**ADDENDUM #1**  
**BID DOCUMENTS FOR**  
**Kohlhoss Water Line Replacement**  
**POOLESVILLE, MARYLAND**  
**CONTRACT 100.062**

February 12, 2024

**ADDENDUM #2**  
**BID DOCUMENTS FOR**  
**Kohlhoss Water Line Replacement**  
**POOLESVILLE, MARYLAND**  
**CONTRACT 100.062**

UTILITY PATCH  
IN FLEXIBLE PAVEMENT

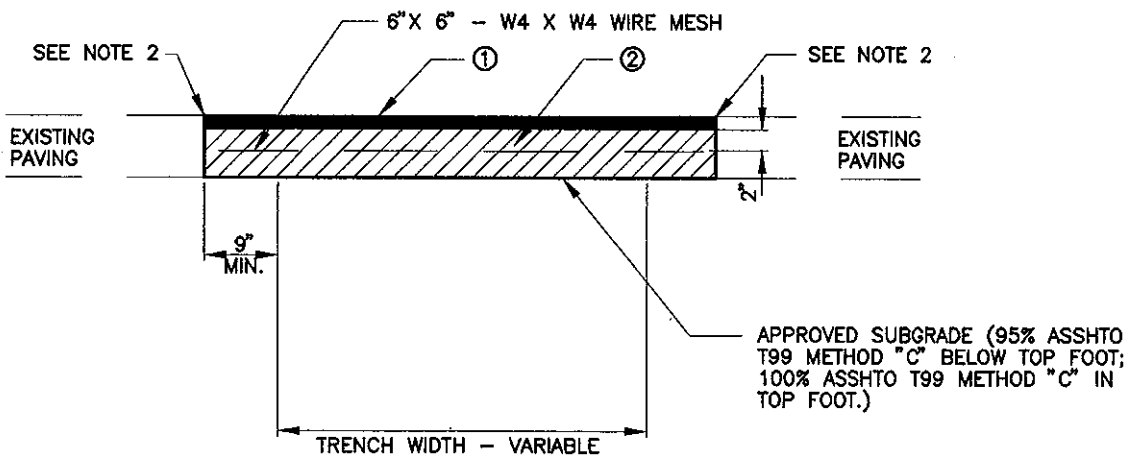
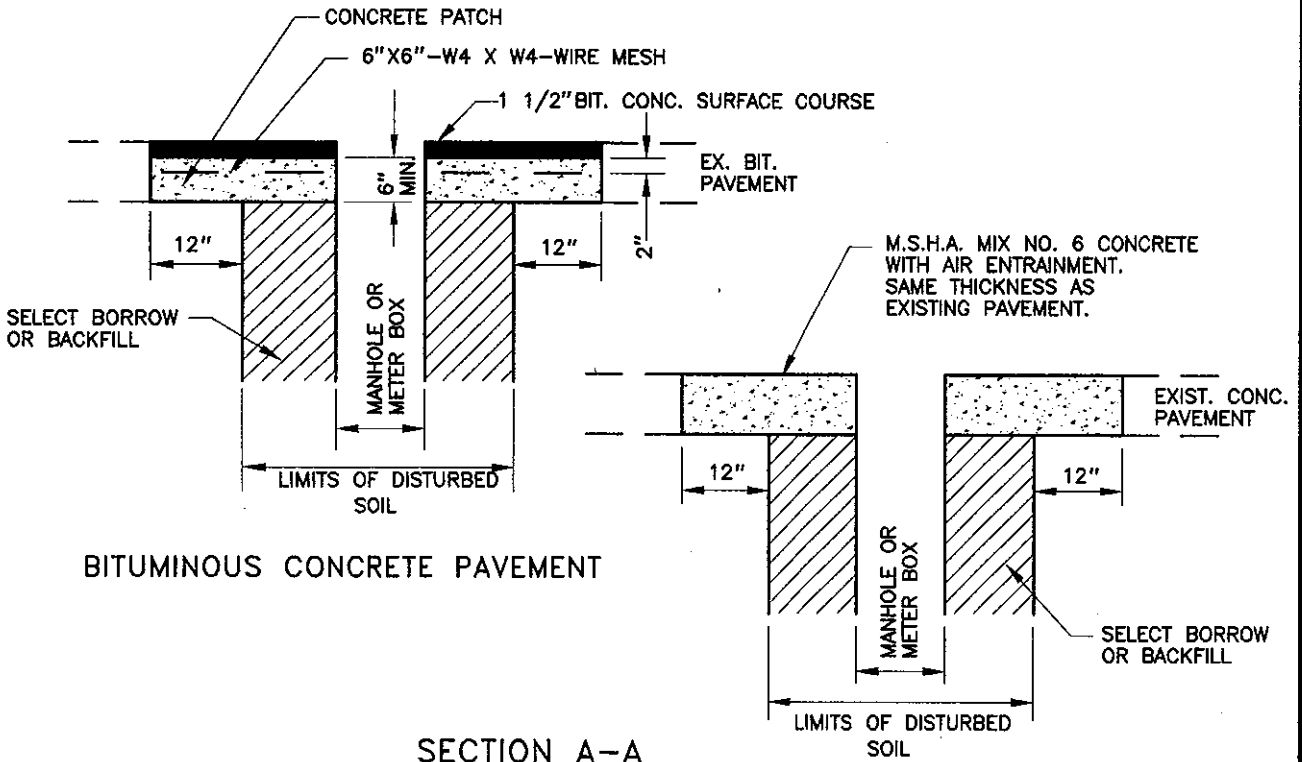
1) the mill and overlay/paving requirement. The drawings show a 5' minimum full depth asphalt replacement in Utility trenches, and then a mill and overlay that appears to be 10' wide. The detail on sheet C-208 detail 3.1 confirms the full depth, but only shows an additional 3" each way for the mill and overlay and shows it as 3", not the 1 1/2" as shown on the drawings  
Answer: please refer to Addendum #1 for Standard Road Patch

- ① TWO - 1 1/2" BITUMINOUS CONCRETE SURFACE COURSE
- ② BITUMINOUS CONCRETE BASE COURSE SEE NOTE 3.
- ③ SUBBASE MATERIAL SEE NOTE 3

- ① 1 1/2" BITUMINOUS CONCRETE SURFACE COURSE
- ② 6" MINIMUM CONCRETE PATCH

- ① 1 1/2" BITUMINOUS CONCRETE SURFACE COURSE
- ② BITUMINOUS CONCRETE BASE COURSE SEE NOTE 3

1. REFER TO M.C.D.O.T. UTILITY PATCH SPECIFICATIONS FOR MATERIALS AND METHODS OF CONSTRUCTION.
2. EXISTING PAVEMENT MUST BE SAW CUT FULL DEPTH PRIOR TO EXCAVATION.
3. BASE COURSE AND SUBBASE MATERIAL SHALL CONFORM TO APPROPRIATE ROADWAY CLASSIFICATION DESIGN STANDARD OR MATCH EXISTING CONDITION, WHICHEVER IS GREATER.
